Re: Bayer MaterialScience LLC, Hicksville, NY; Soil Vapor Investigation Report, dated December 20, 2007

Subject:
Bayer MaterialScience LLC
125 New South Road
Hicksville, New York
USEPA ID#: NYD002920312
Soil Vapor Investigation Report

Date:
December 20, 2007

FIGURE
1

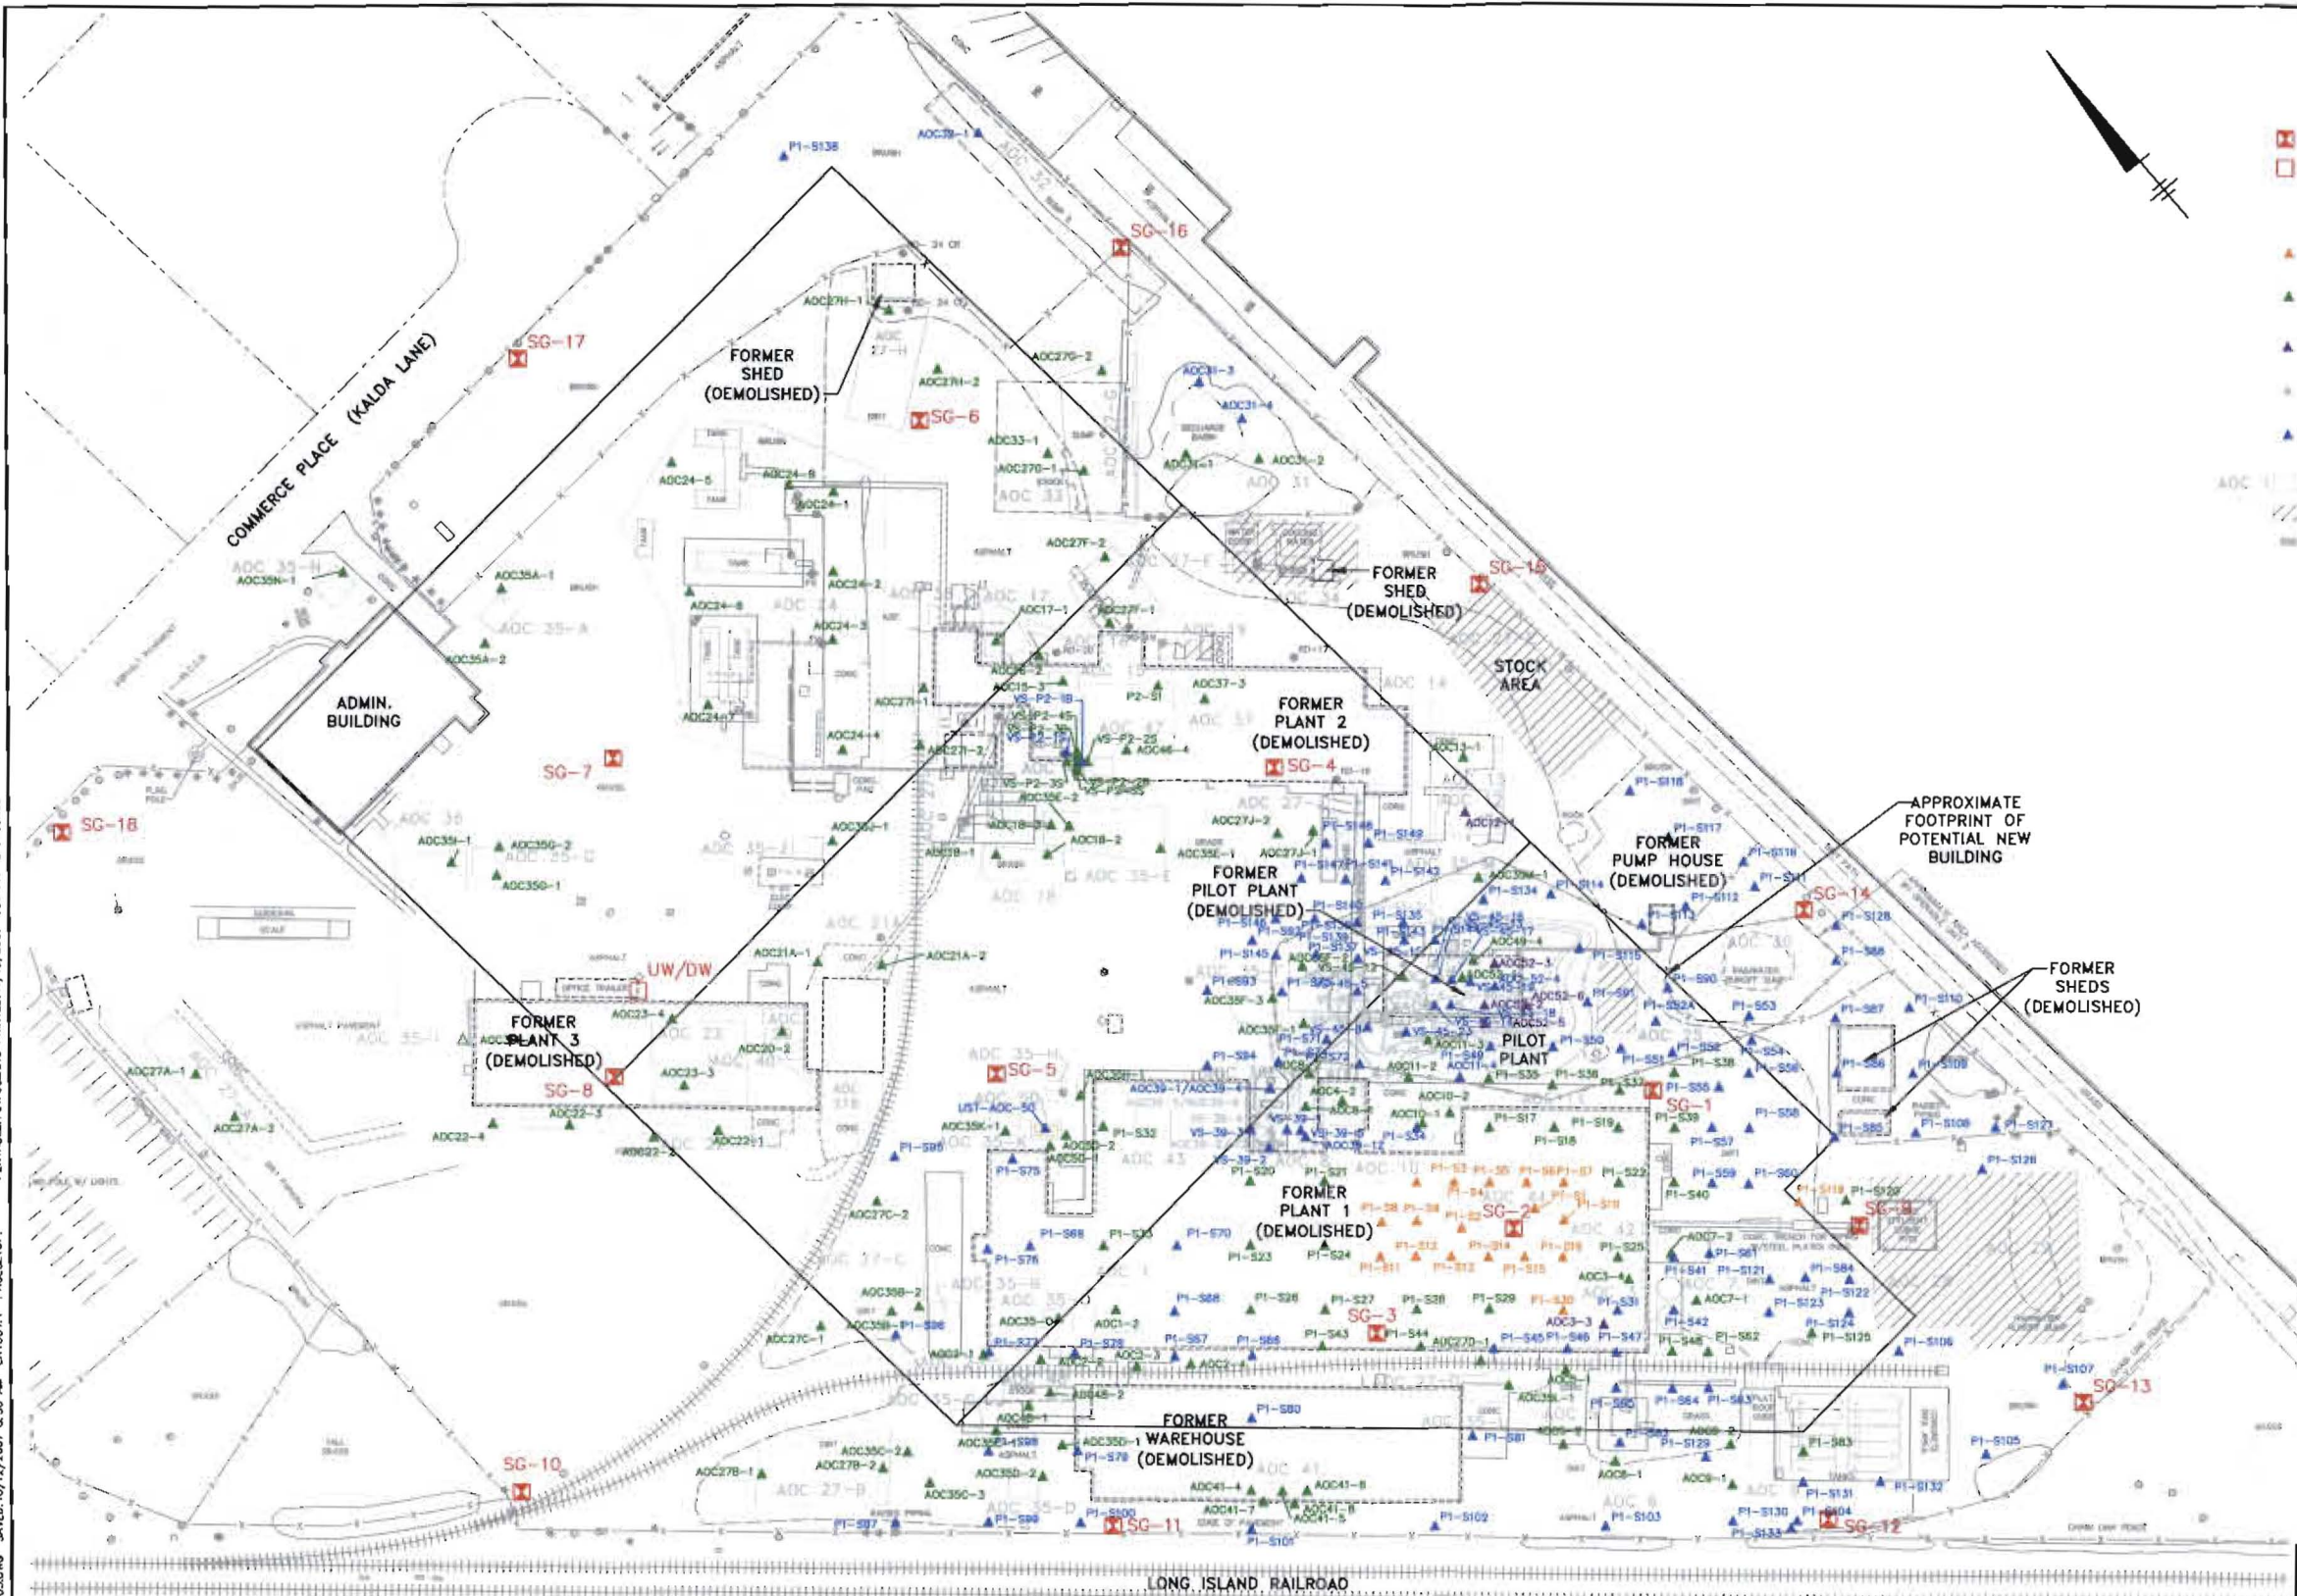
-
- 1/17/07 - Teleconference call w/ DOH (Feneta Ockedby & Jackie Nelson)
- Add sampling point btwn SG-13 & SG-14, in front of SG-9.
 - Add sampling point south of SG-14.
 - Add two sampling points btwn SG-10 & SG-18 (in front of SG-8).
 - Nassau Co. Health Contact, Bob Weitzman, 516-571-4139 (direct line)
516-571-3233 (Secretary)
3323 (?)

FIGURE
2

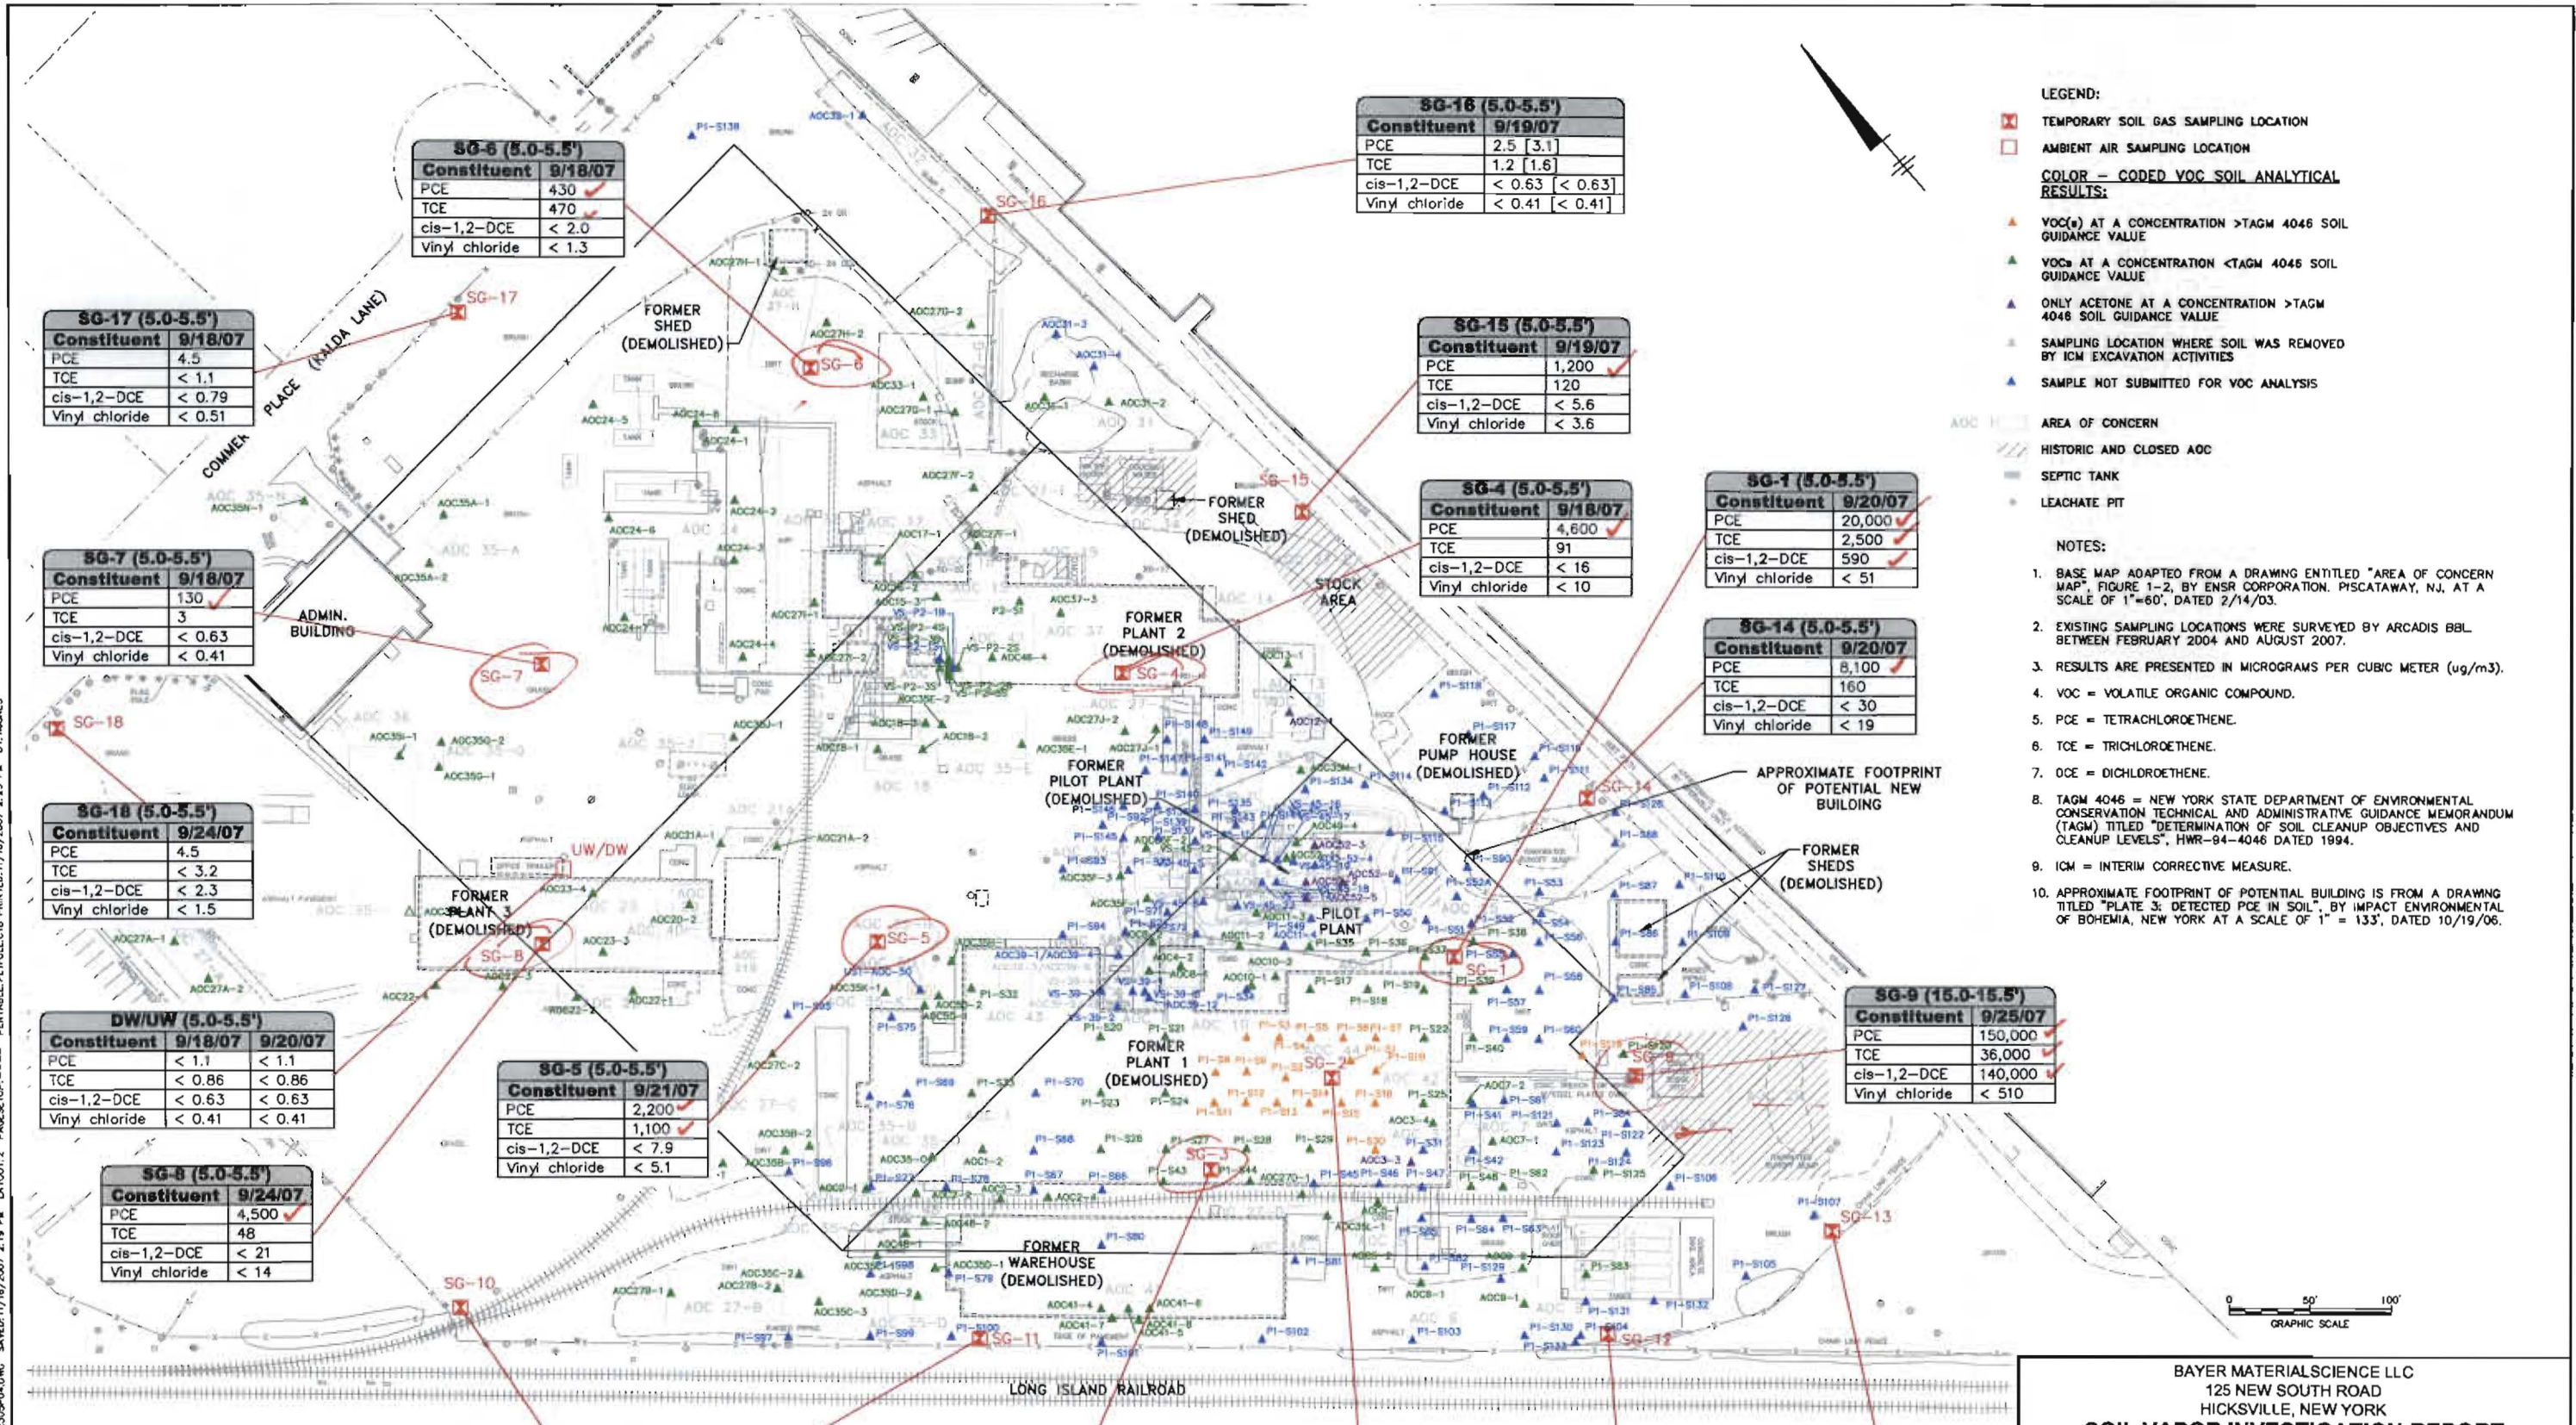
- OK
- More soil gas sampling should be completed in area of SG-2 (at Former Plant 1 area) to determine extent of vinyl chloride contamination (vinyl chloride was 10,000 $\mu\text{g}/\text{m}^3$).

- Need more sampling along south-southwest site boundary adjacent to Long Island Railroad. Bayer needs to determine the extent of PCE and TCE soil gas contamination in this area and if it is potentially migrating off-site. Analytical results vary depending on location. SG-10 is low; SG-12 was slightly high for PCE (64 $\mu\text{g}/\text{m}^3$); SG-11 and SG-13 were high for PCE (2400 $\mu\text{g}/\text{m}^3$ and 2700 $\mu\text{g}/\text{m}^3$, respectively). - 56 - 11

- More sampling is needed in areas of SG-14 and SG-15 along eastern property boundary. PCE was 8100 $\mu\text{g}/\text{m}^3$ at SG-14 and 1200 $\mu\text{g}/\text{m}^3$ at SG-15.

Further sampling in this area for VCl.

*SG-15 + SG-14 are
high for PCE (1200 +
8100, respectively).*
